CONTRACT NO. PW. 1029
DEPARTMENT OF PUBLIC WORKS DETROIT
CITY ENGINEERS OFFICE - DIVISION OF PAVING DESIGN
STREET PAVING PLAN
SNOWDEN
N.P.L. ST. MARTINS
FROM 3540 S.P.L. PEMBROKE
RECORD NO. 6487
INDEX TOP NO. 49-24
NAME OF STREET SNOWDEN
ASSIGN NO. 235-1
SHEET OF 1
SHEETS
WIDTH 30'

Change Order to Order - 10-27-49

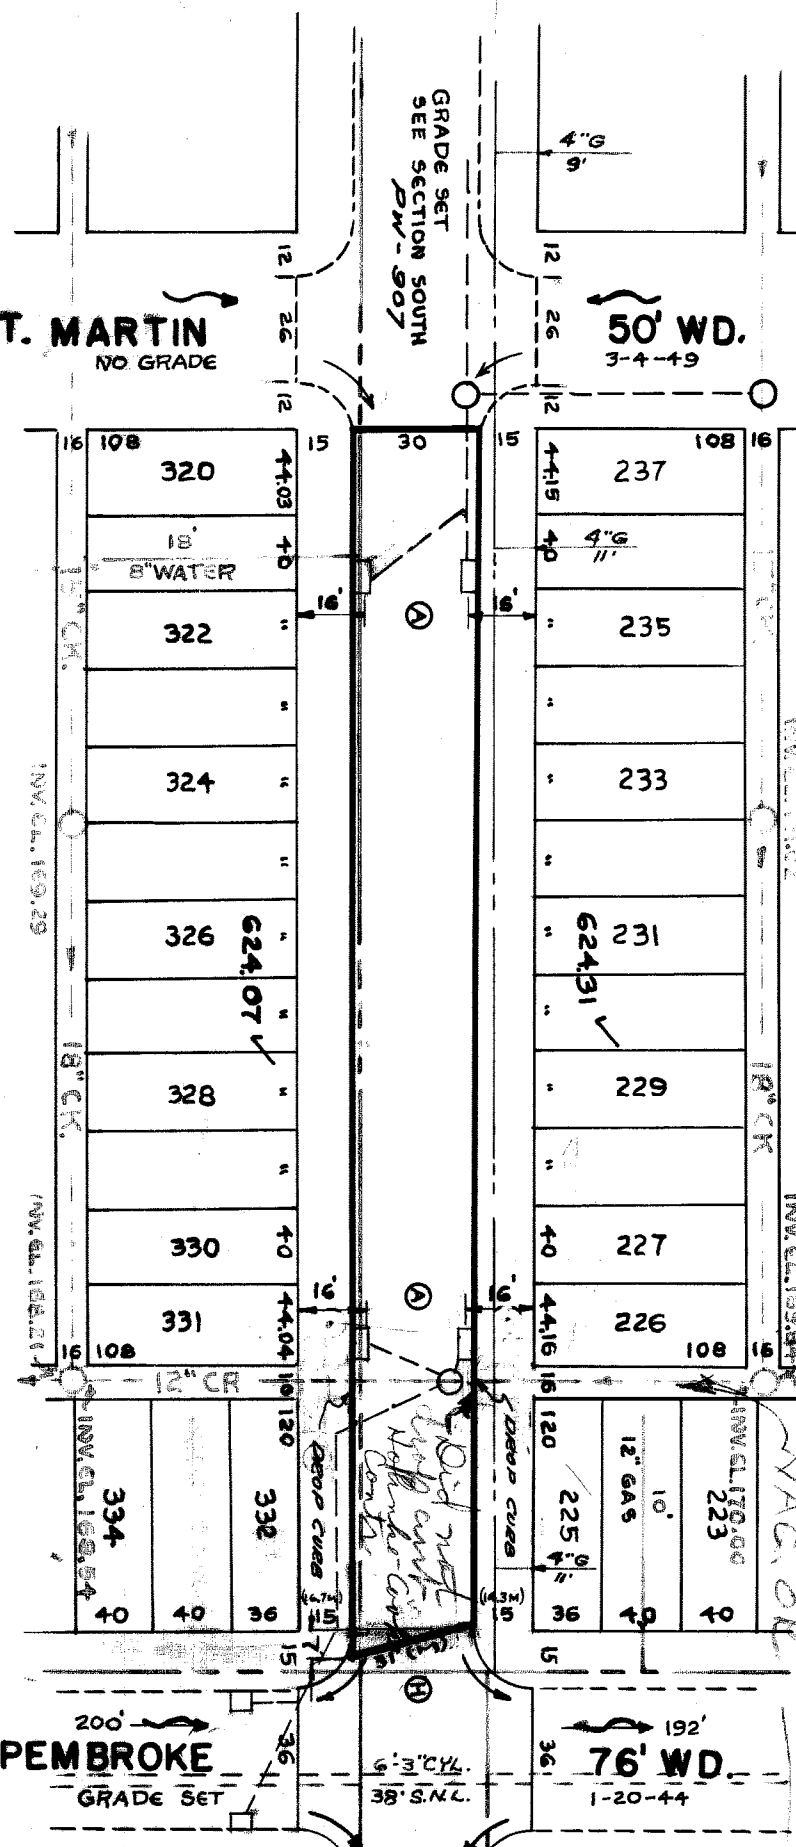
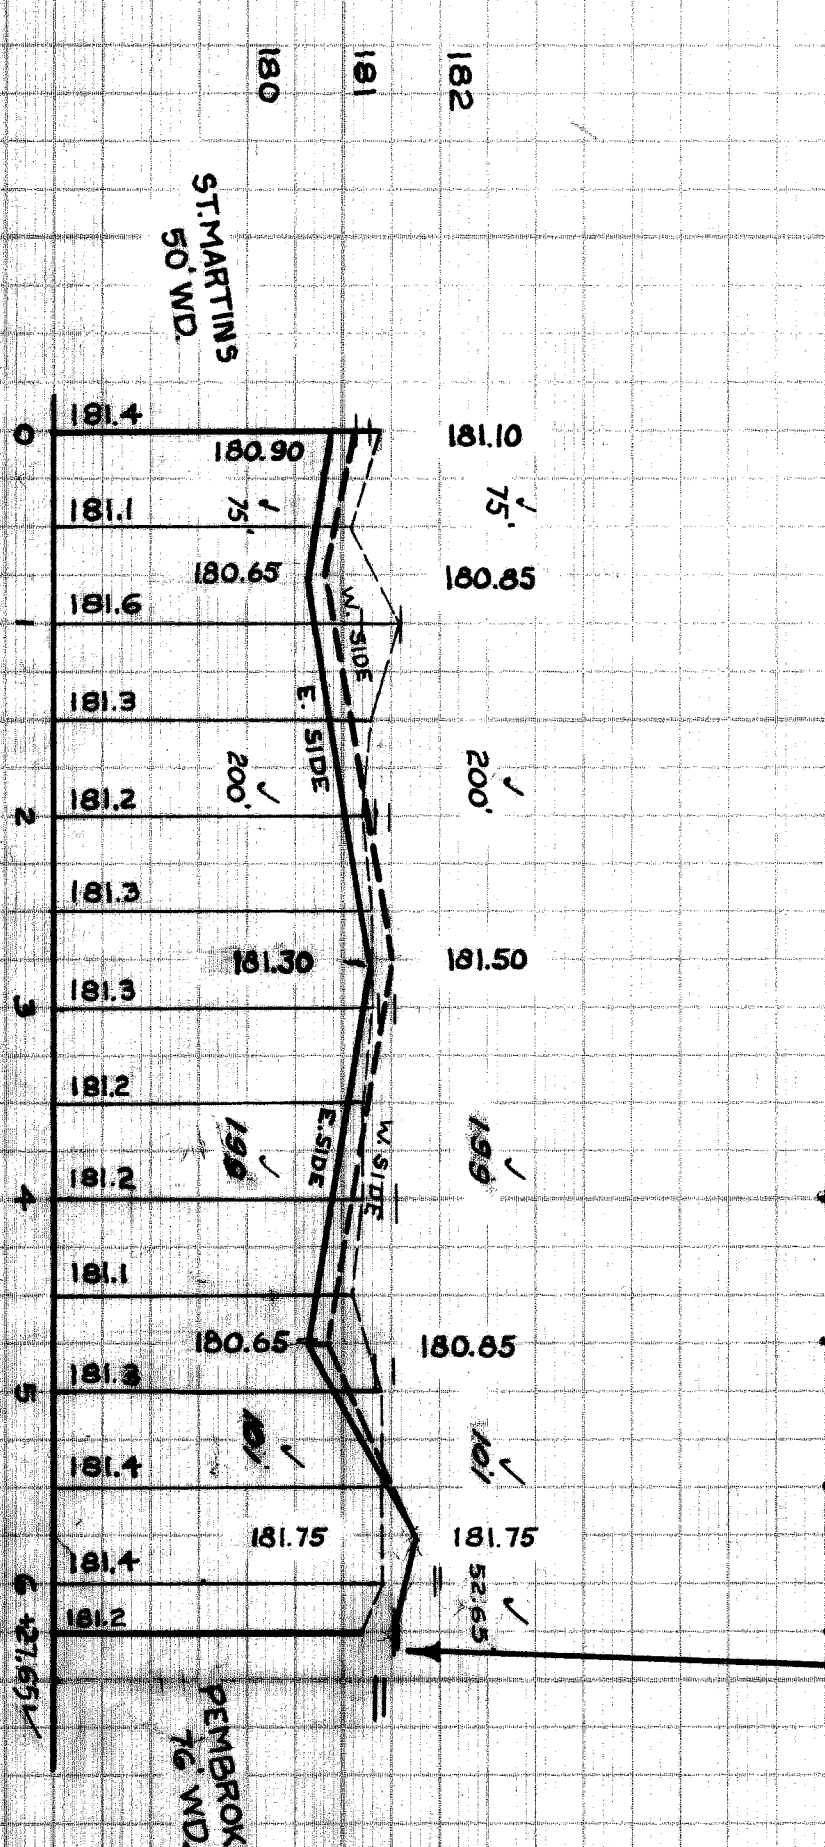
10-26-49
ADJUSTMENTS IN QUANTITIES OF CITY
PORTION, DUE TO OMISSION OF ALLEY
RETURNING
EXCAVATION
PAVING 8" 6" 6"
SIDEWALKS
30 CU. YDS.
36 SQ. YDS.
72 SQ. YDS.

- Notes**
- AT (M) CONSTRUCT 108 SQ. FT. OF STANDARD 4" CONCRETE WALK.
 - AT (M) ADJUST TOPS OF 4 EXISTING 18" 12" BASINS WITH FLAT TYPE FRAMES AND GRATES.
 - CONTRACTOR SHALL REMOVE CONCRETE HEADER AND BROKEN ASPHALT BACK OF JUNCTION AS REQUIRED AND FILL WITH COLD PATCH TO MEET NEW GRADES. 10 CU. YDS. INCLUDED UNDER EXCAVATION TOTALS FOR COST.
 - ADJUST TOPS OF 7 WATER MANHOLES
 - ADJUST TOP OF 1 SEWER MANHOLE.
 - RECONSTRUCT CONE OF 1 SEWER MANHOLE, IF NECESSARY.
 - CONTRACTOR SHALL FURNISH ALL NECESSARY MATERIALS, INCLUDING CASTINGS AND SHALL HAIL ALL SALVAGEABLE MATERIALS TO D.P.W. YARD AT STATE FAIR AND JOHN R. STREETS.
 - DIRT ALLEYS AT ENDS OF PAVEMENT SHALL BE GRADED BACK AND STORED 6" DEEP UNIFORM, FOR A DISTANCE OF 10 FT. TO MEET EXISTING GRADES. 24 CU. YDS. IS INCLUDED UNDER EXCAVATION TOTALS FOR COST.
